Product Change Notice (PCN)

PCN Number: PCN-0450726R-01

Product(s) Affected: PJ-002AH-SMT-TR, PJ-002BH-SMT-TR

Current version	New version
	 <p>housing</p>	 <p>housing</p>
Outlook	 <p>pin# 3</p>	 <p>pin# 3</p>

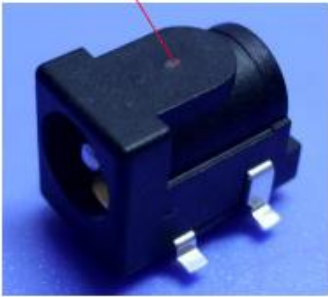
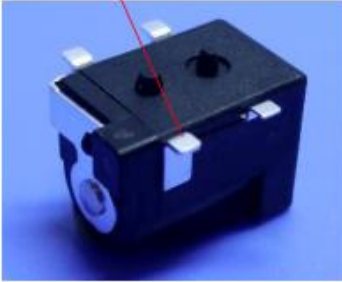
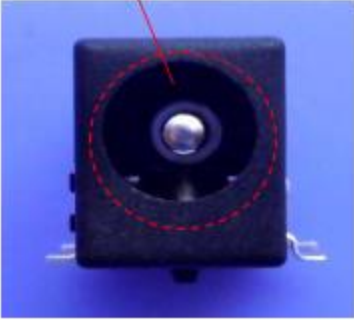
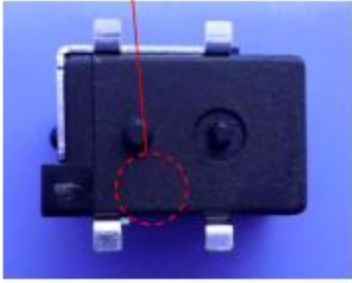
Reason(s) for Change: existing plastic housing and pin 3 molds cannot maintain efficient production.

Description of Change: to ensure quality and production efficiency, new mold development is in process. Aesthetic changes as shown below. Electrical structure and function remain unchanged.

Front	<p>jack hole without chamfer</p> 	<p>jack hole with chamfer</p> 
Bottom	<p>without cave marking</p> 	<p>cave marking location</p>
